1.0 USE AND APPLICATION

- A. This change reflects a change to NUREG-1431 submitted to the NRC by the Industry Owners groups via the generic STS change process.
- B. Removal of brackets and/or addition of plant specific parameter or information.
- C. Correction of typographical error in the Proof and Review TS.

Figure B 3.2.1-1 (page 1 of 1)
K(Z) - Normalized F₀(Z) as a Function of Core Height

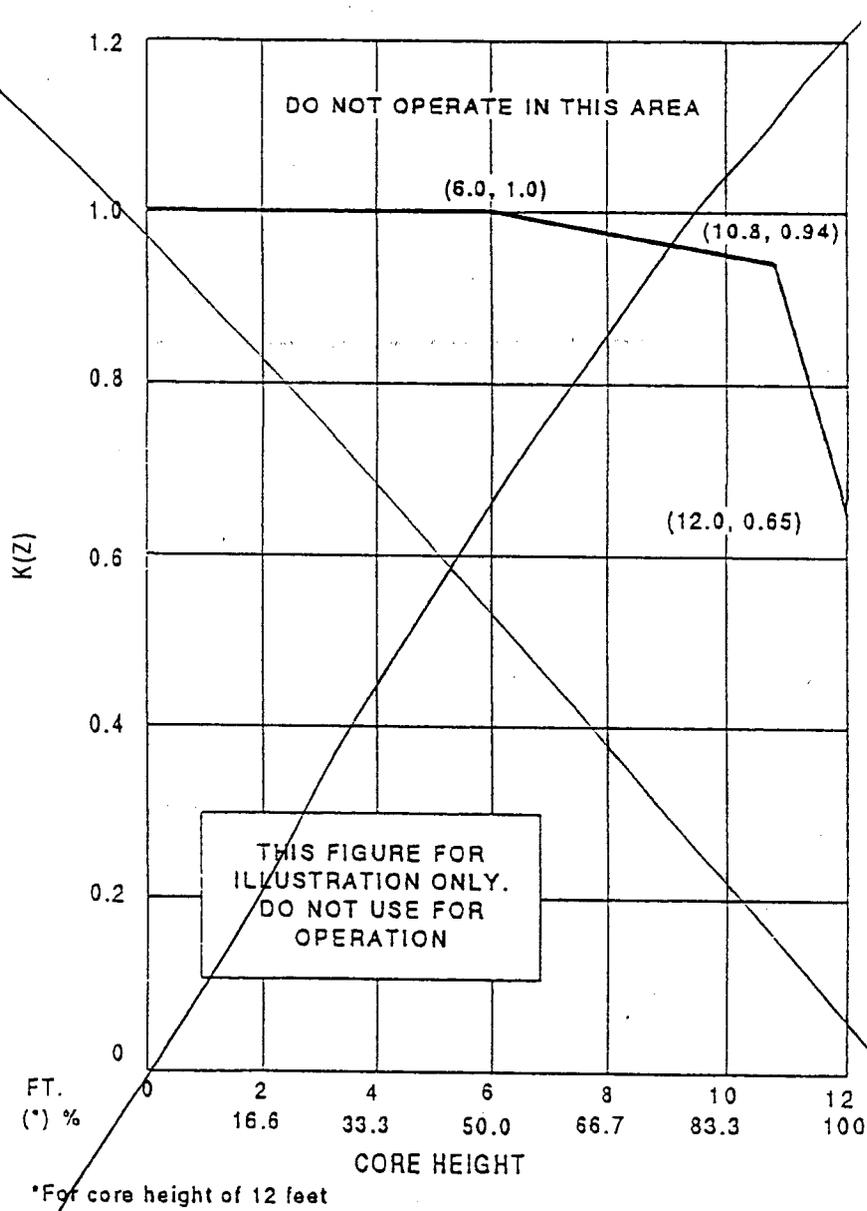
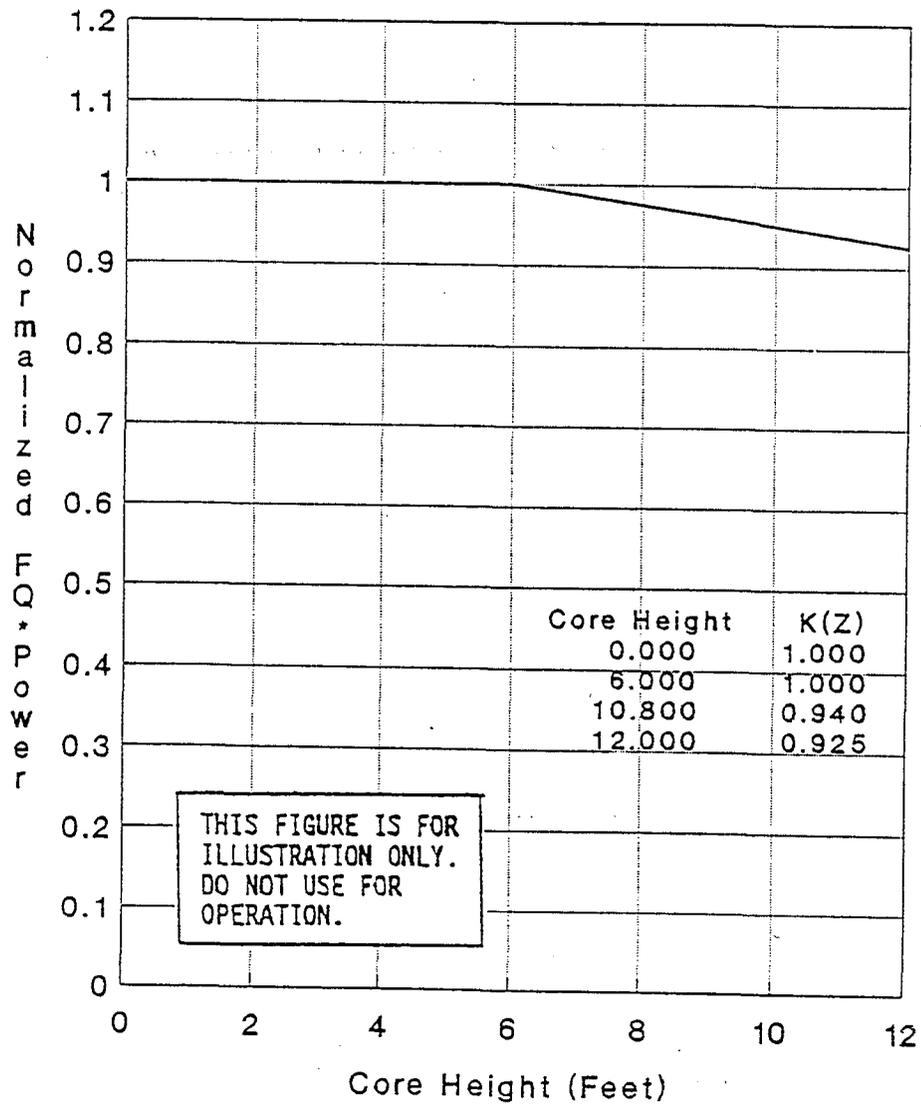
replace with attached figure

Figure B 3.2.3-1 (page 1 of 1)
AXIAL FLUX DIFFERENCE Acceptable Operation Limits
as a Function of RATED THERMAL POWER

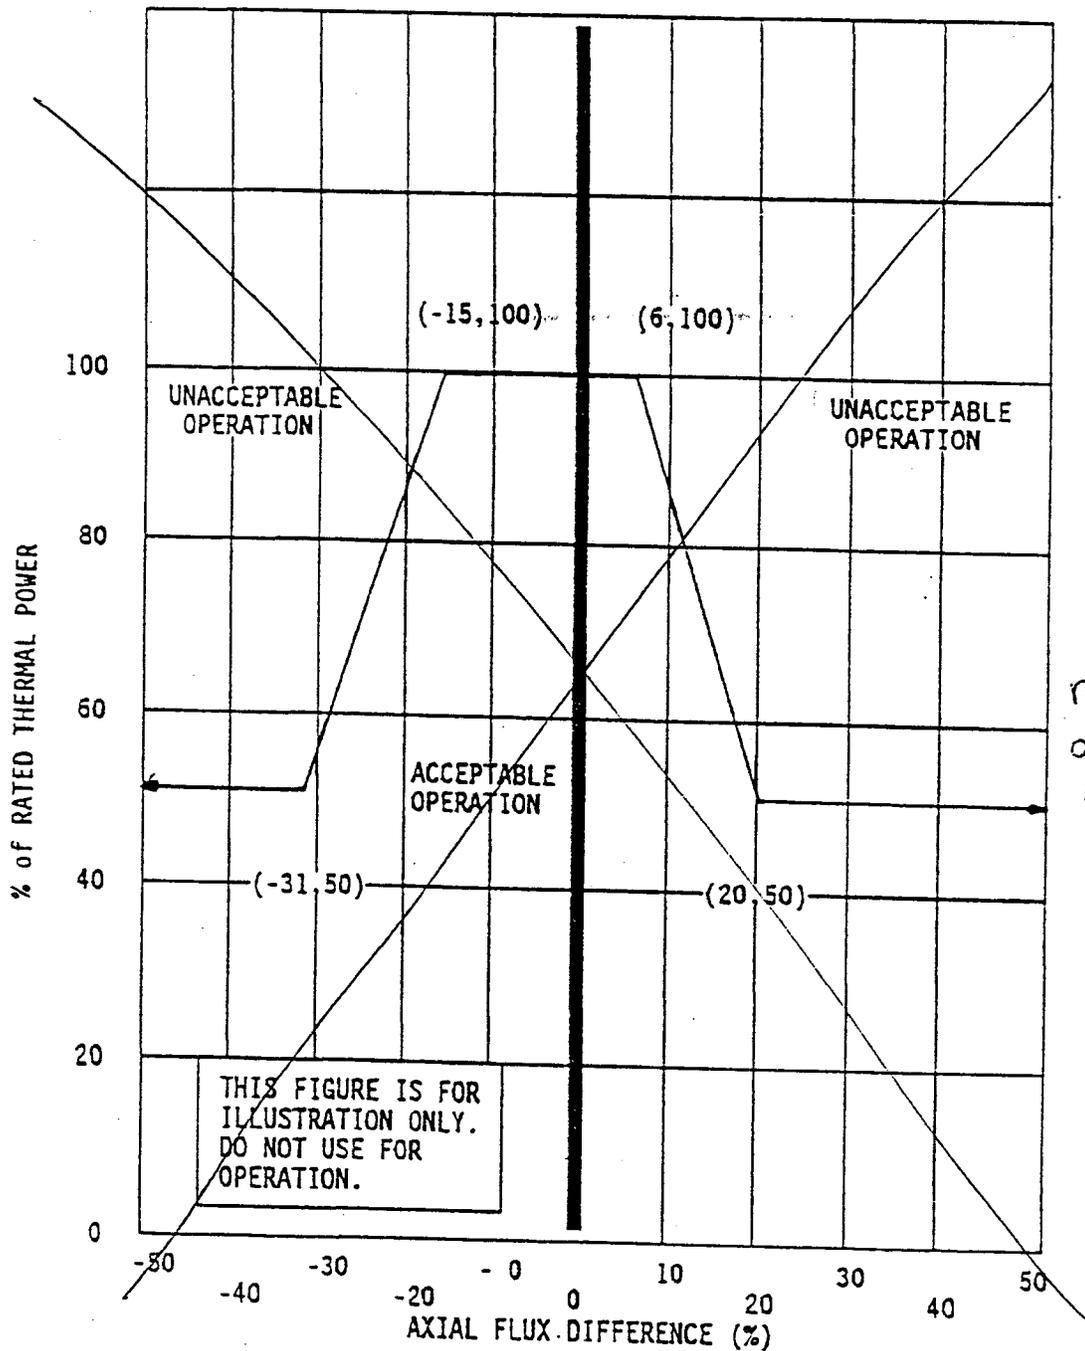
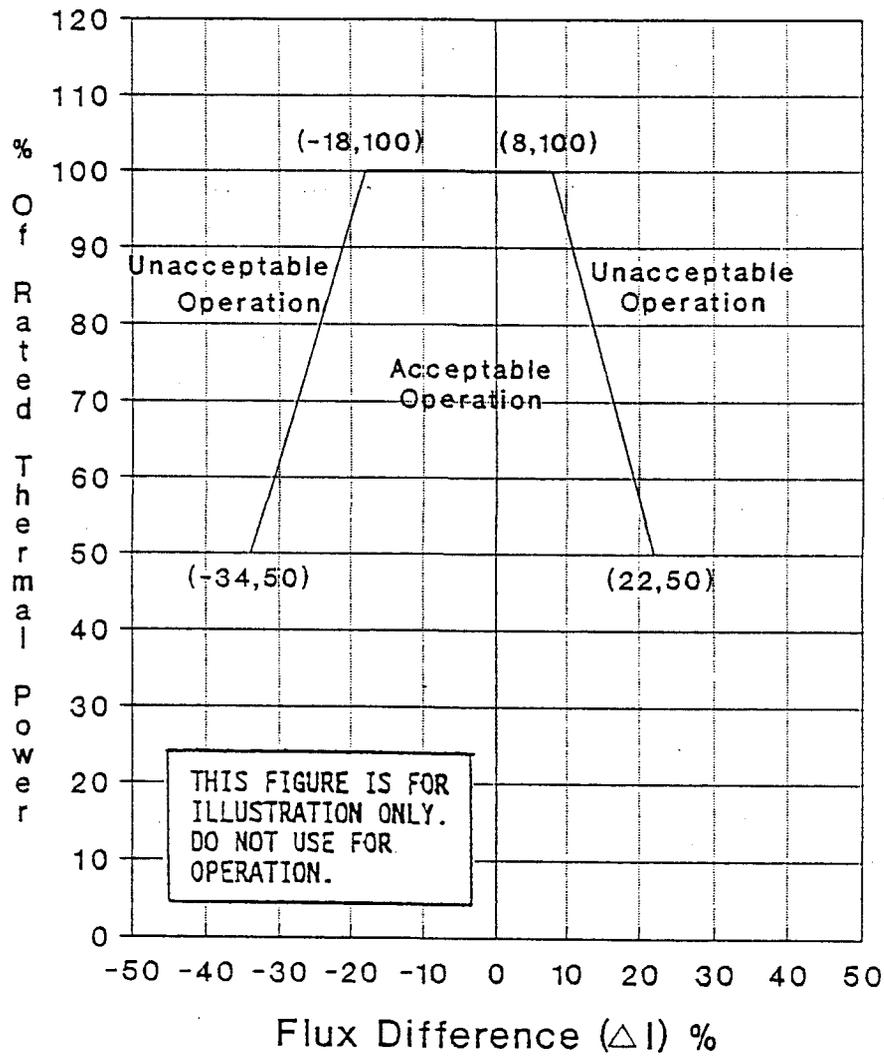
ⓑ
replace with
attached
figure
